Certification Label

| Bulletin Type: | Recall | Publication Date: | March 2023 |
| Bulletin #(s): | 23V-102 US 2023-082 Canada | Make(s): | Jayco and Entegra Coach |

Certification Label

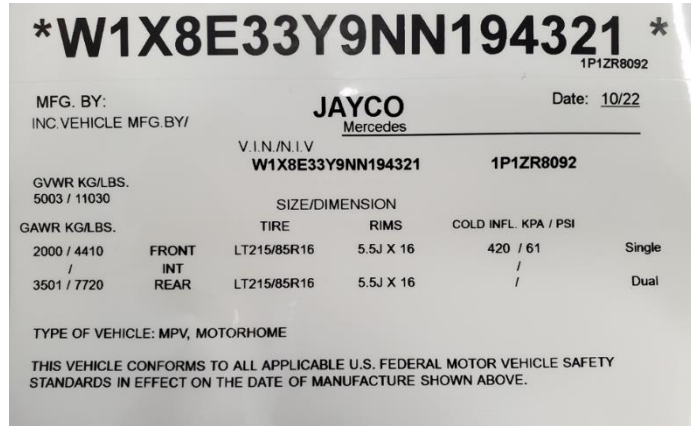
| Incident: | The certification label may be missing the rear axle information including the Gross Axle Weight Rating (GAWR). |

The certification label below is only an example of the label you are to replace.

Remove existing label

1. **Class A** models locate the label on the inside of the RV at the interior wall next to the driver’s seat. **Class B** and **Class C** models locate the label on the inside of the driver’s door.
2. Remove the existing label. Using isopropyl alcohol and a shop rag, remove any adhesive residue from the surface where the original label was removed.
 - a. Allow the area to dry for at least 30 seconds.

Apply new label

1. Remove the protective back from the new label. Align the new label in the same location of the original label and apply it to the surface. Remove any air bubbles from the label.
 - a. Note: Do not attempt to remove or adjust the label once it has touched the surface. Doing so may damage the label or cause it not to adhere properly to the surface.
